FIELD ORDER SUMMARY

Project: Saranac Lake Gas Co. Remedial Action	Project Location: Village of Saranac Lake, Essex County, New York
Client: NYSDEC	NYSDEC Site No.: 516008
Contractor: LAND Remediation, Inc.	MACTEC Project No.: 3611181219

FIELD ORDER

Project Name:	Saranac Lake Gas Company, Remedial Action	FO No.: 1
Project Location:	Village of Saranac Lake, Essex County, New York	Date Issued: 7/17/2018
		Site No.: 516008
Client:	New York State Department of Environmental Conservation (Department)	Contract No.: D010663
Contractor:	LAND Remediation, Inc.	Associated RFI or PCO: <input type="checkbox"/> RFI No. ___ <input checked="" type="checkbox"/> PCO No. 4 <input type="checkbox"/> None
MACTEC Project No.:	3611181219

OU2 BRANDY BROOK
CULVERT MODIFICATION

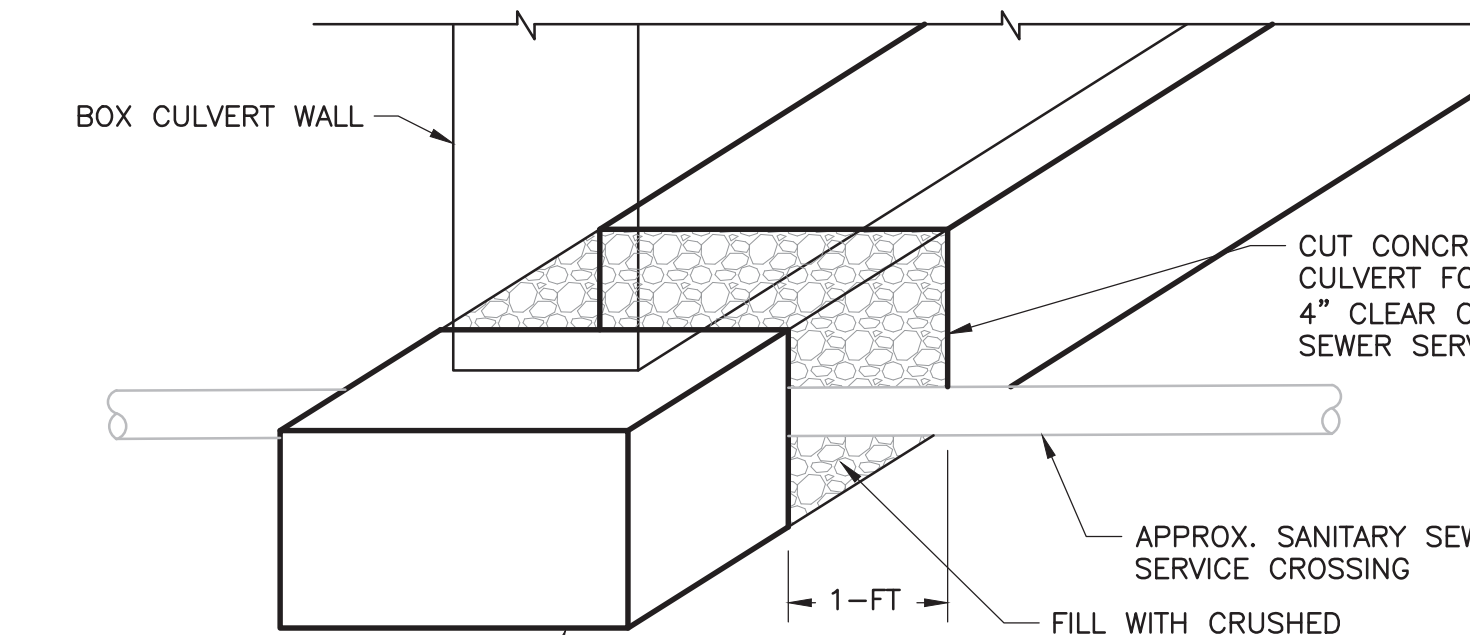
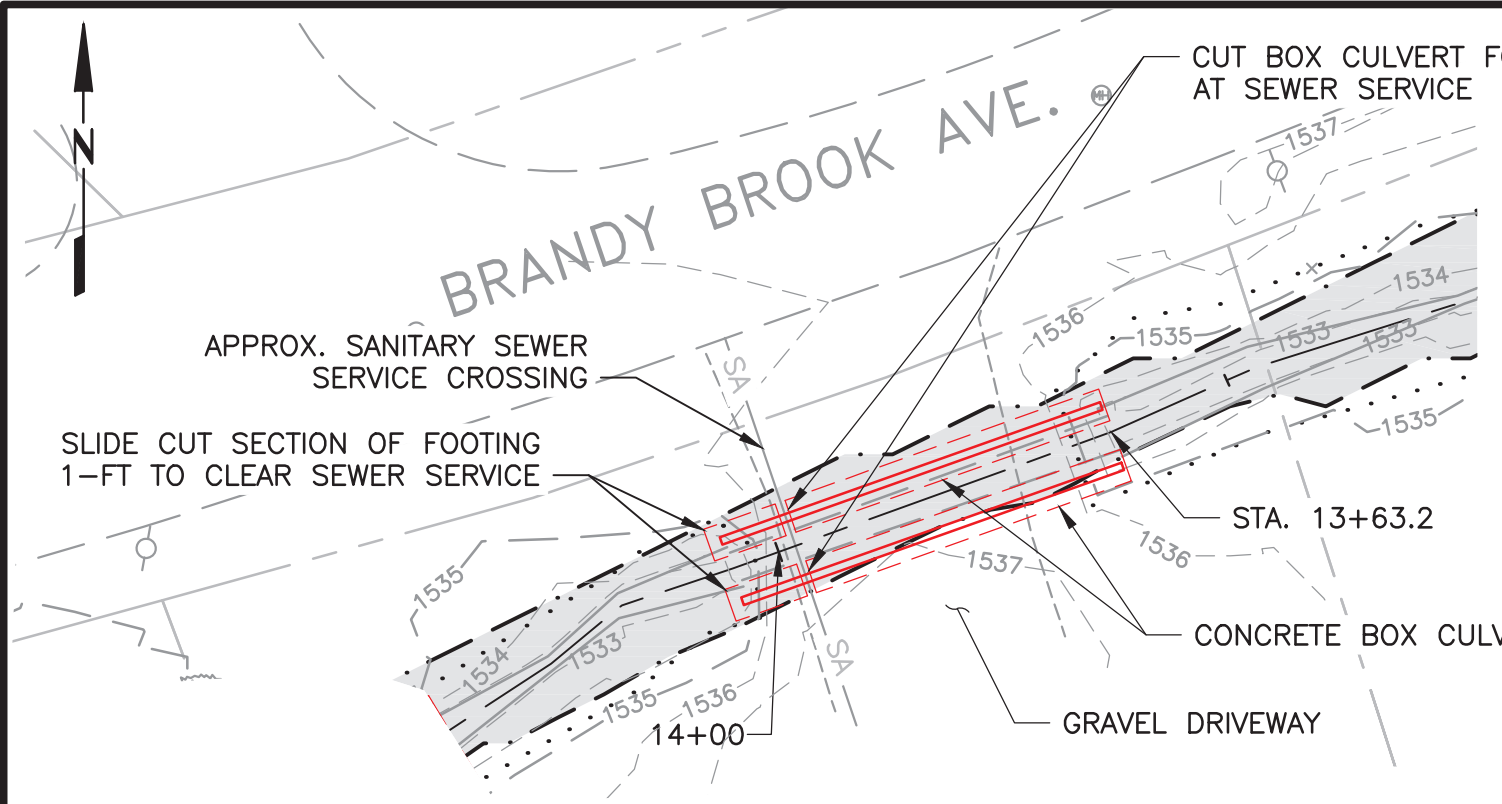
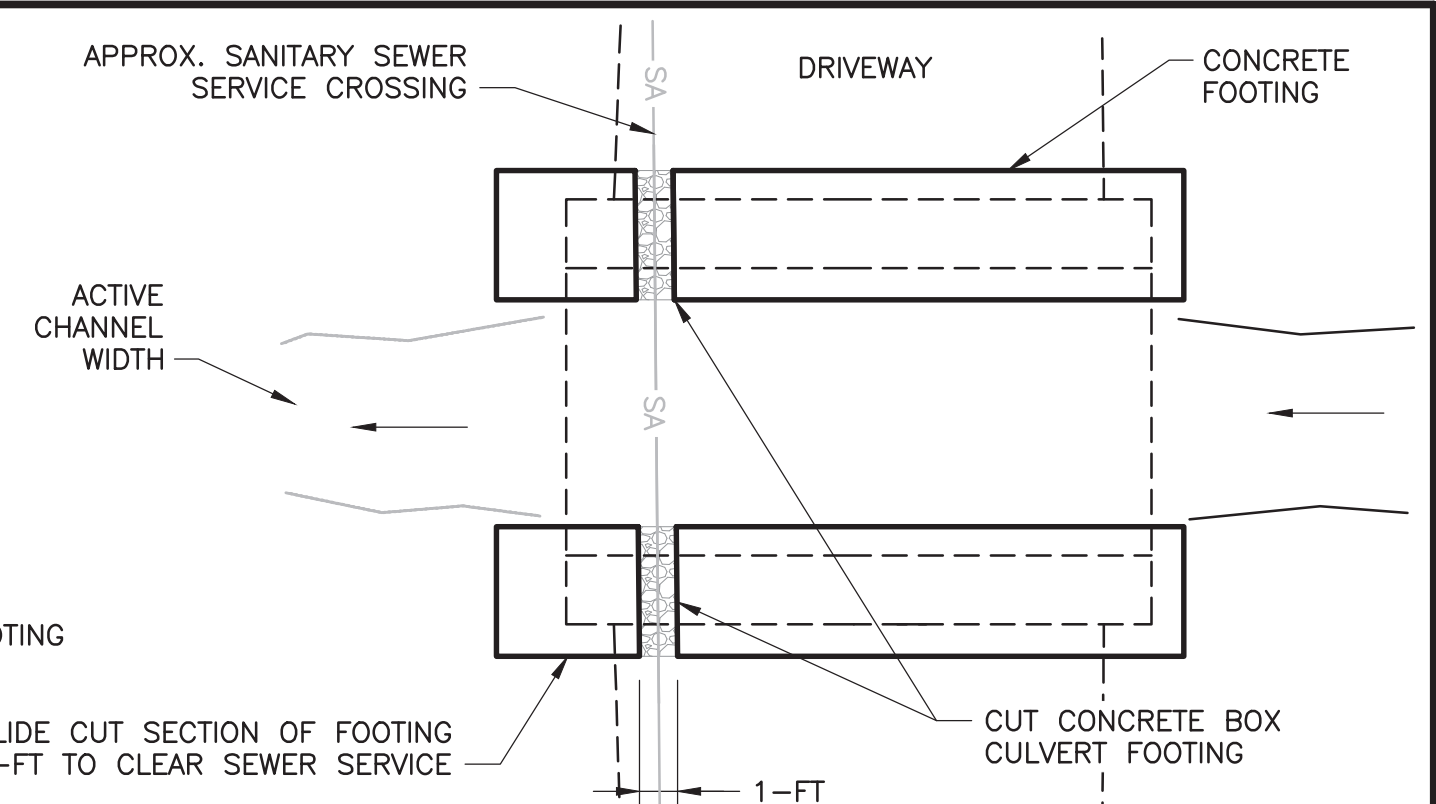
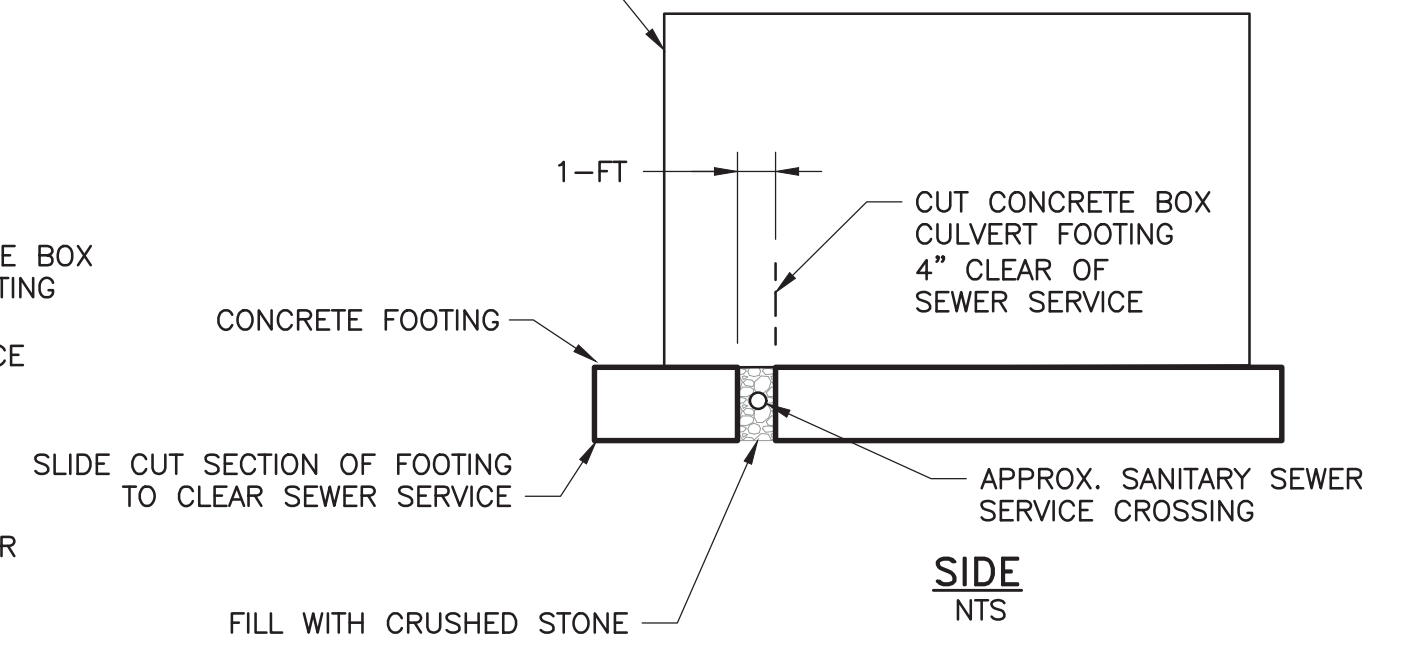
Description of the Work: Modification of the footing for the concrete box driveway culvert to be installed at Station 13+63 to 14+05 on Brandy Brook to avoid conflict with a sewer service lateral.

the modified culvert footing detail at the sewer service lateral location.

SLIDE CUT SECTION OF FOOTING 1-FT TO CLEAR SEWER SERVICE

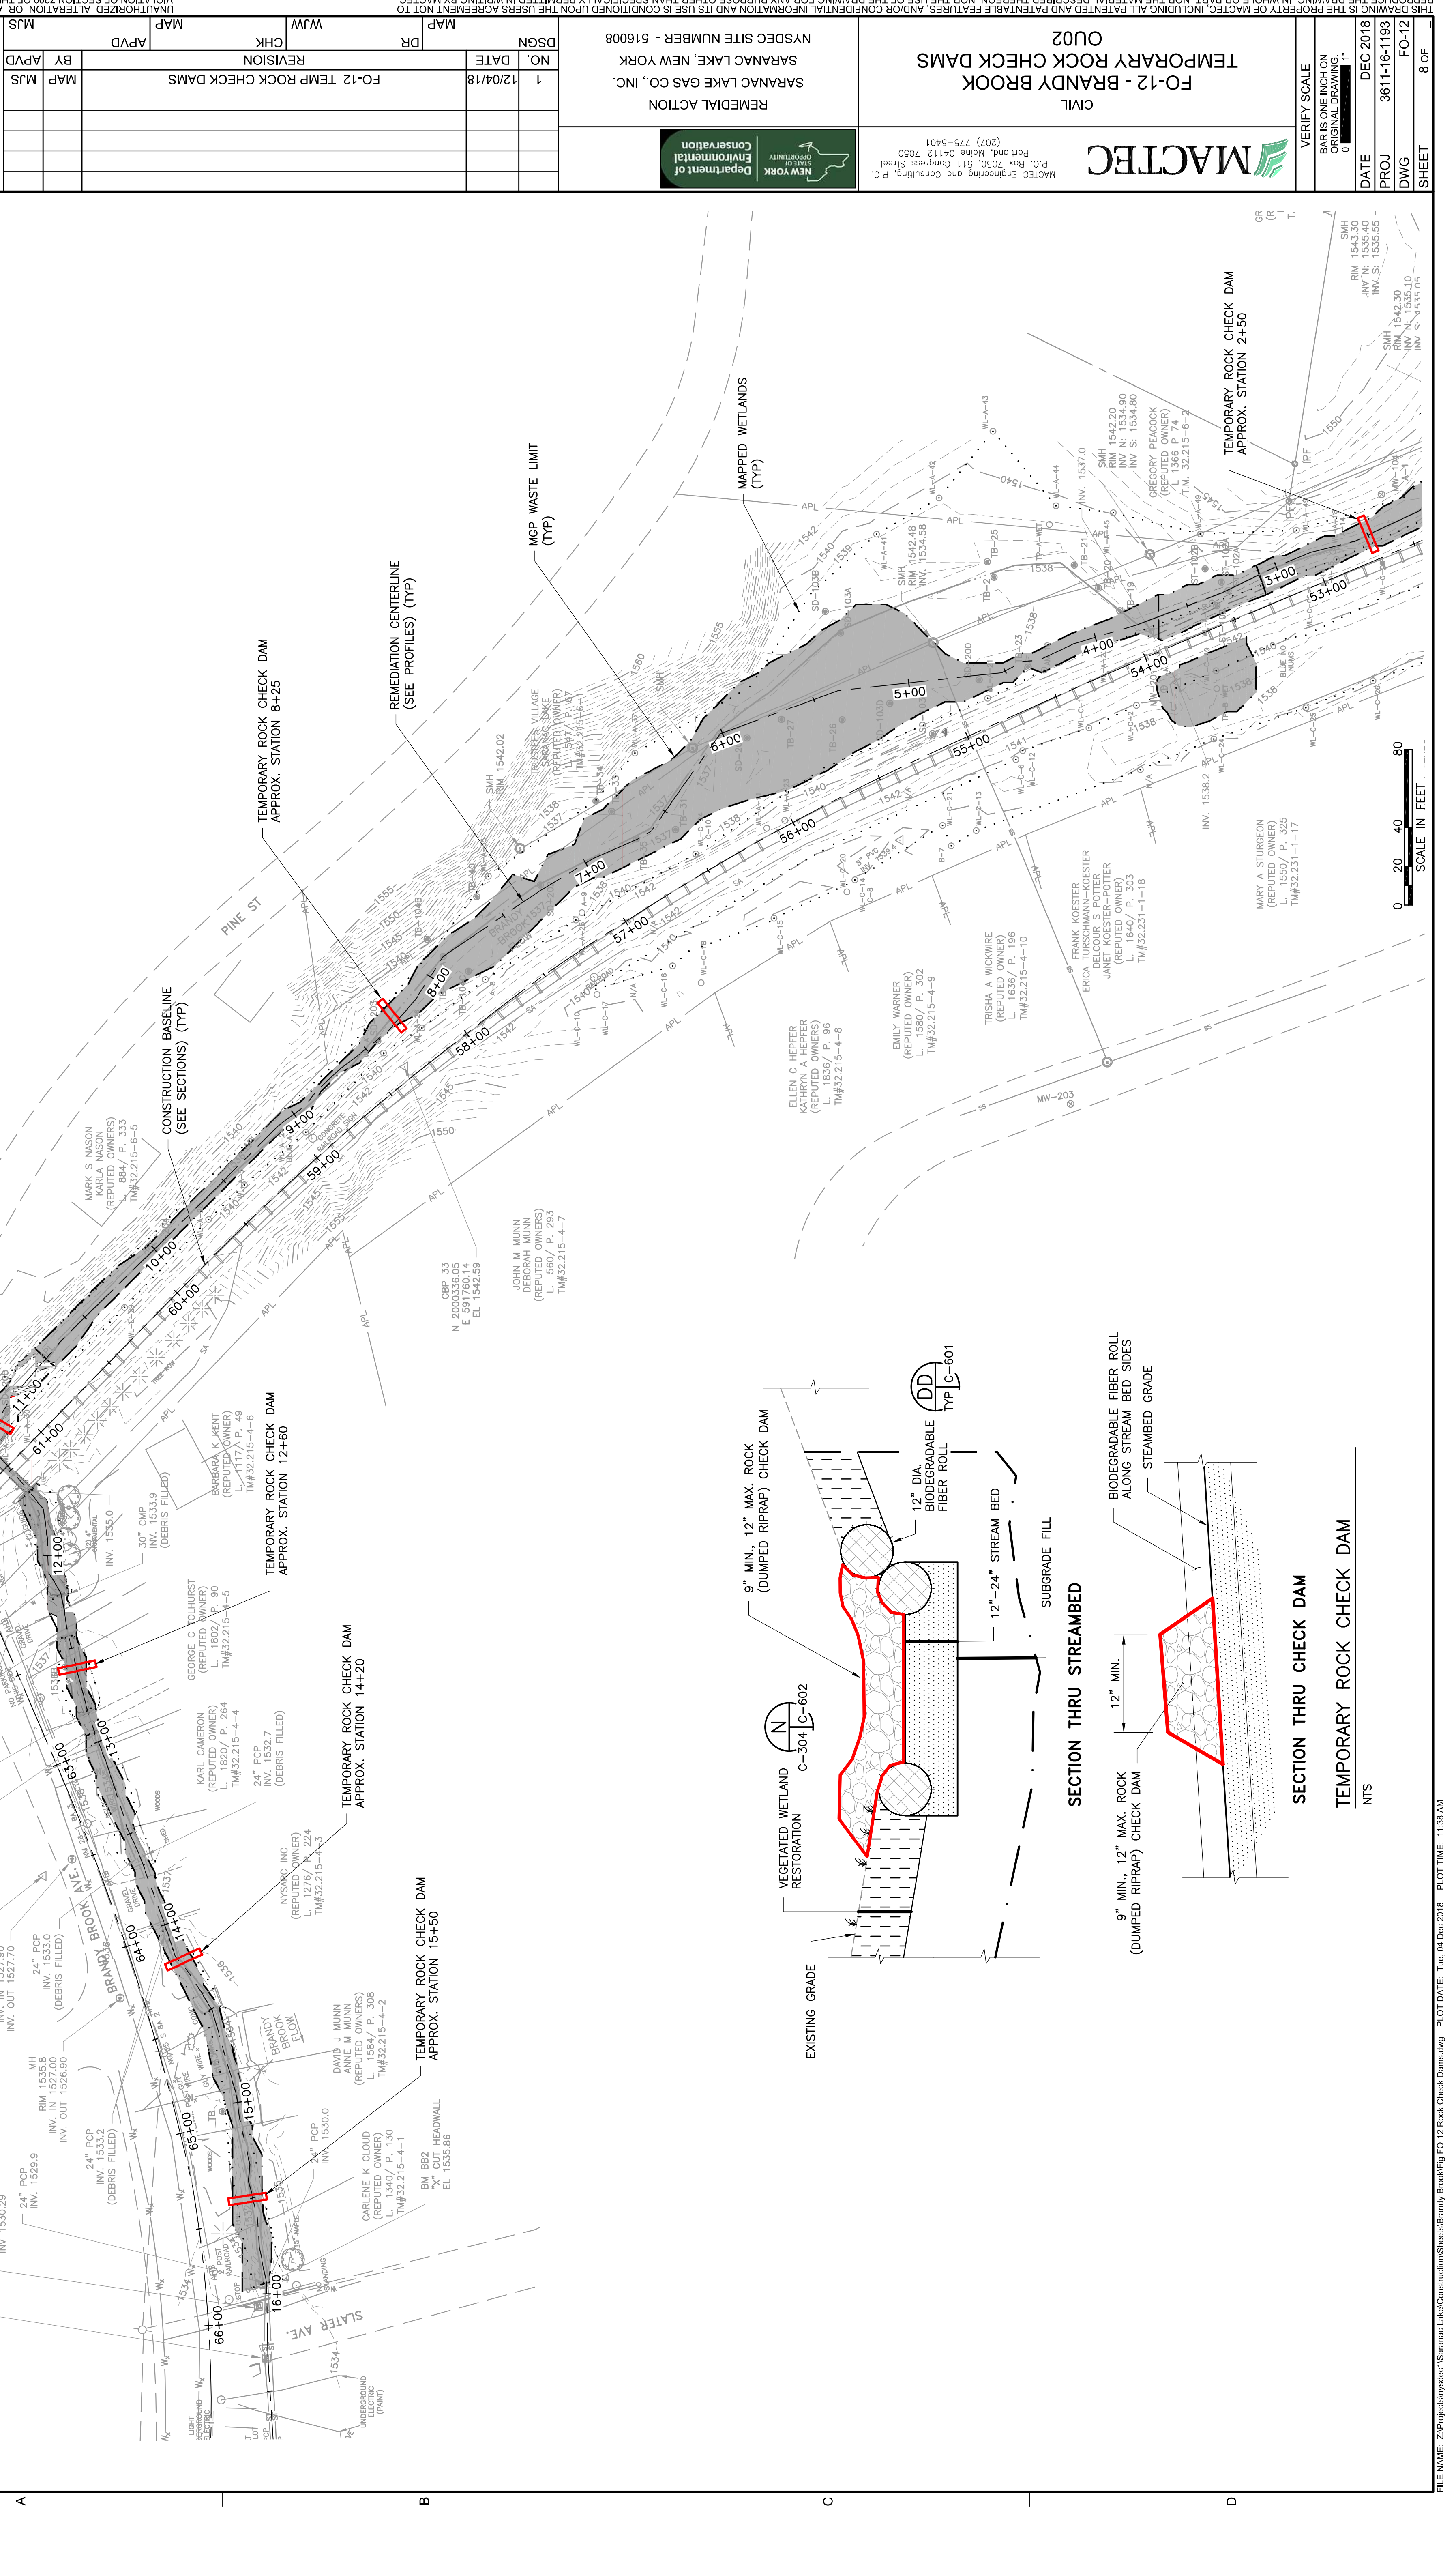
To control initial loss of fine particles from the Streambed Material when flow is reintroduced into the restored Brandy Brook, and to allow time for the brook to self-armor and stabilize, this Field Order directs LAND to install rock check dams (dumped riprap stone) at a number of locations along the brook prior to re-directing bypass flow to the reconstructed channel as part of the winterization control measures. Refer to the attached Figure FO-12 for the installation locations and check dam detail.

FO14-01 Existing driveway with new curbing at 38 and 42 River Street

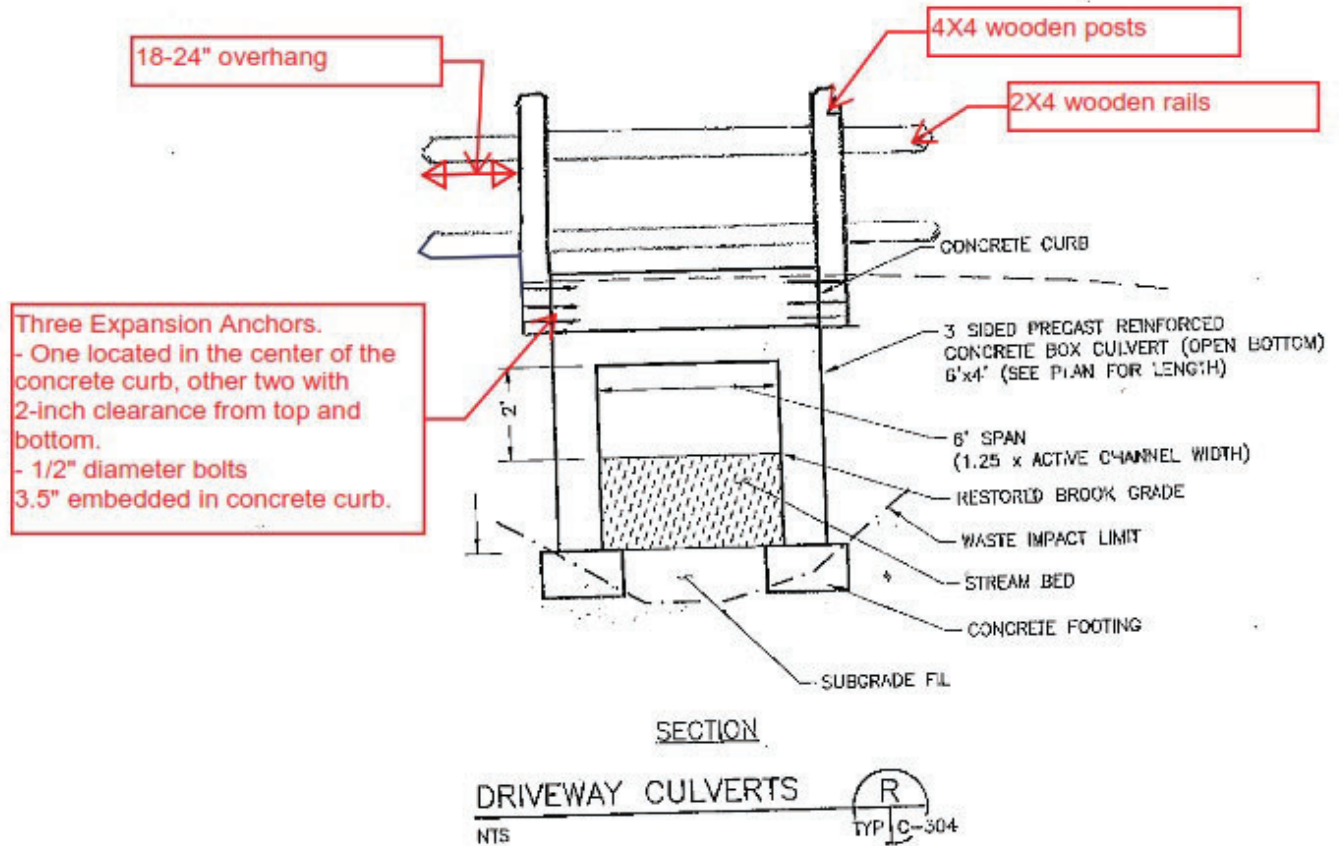
MACTEC Comments:
 In accordance with Specification Section 01 71 33 – Protection of The Work and Property - 1.06-D - “All other existing surface facilities, including but not limited to, guard rails, posts, guard cables, signs, poles, markers, and curbs which are temporarily removed to facilitate installation of the Work shall be replaced and restored to their original condition”, LAND is directed to replace guard rails along the installed curbing in front of 38 and 42 River Street which were removed to facilitate the Work. Railings shall resemble a split railing fence as was previously installed (Photos FO14-02). Both railings shall consist of two 4” X 4” wooden posts anchored to each end of the curbing, with two 2” X 4” split rails. Split rails shall extend 18 – 24” past the post. Ends of posts and rails shall be trimmed to provide a nice finish, and the railing shall be painted or stained dark brown to match the previous railing and the existing railing on the front steps. See sketch below.
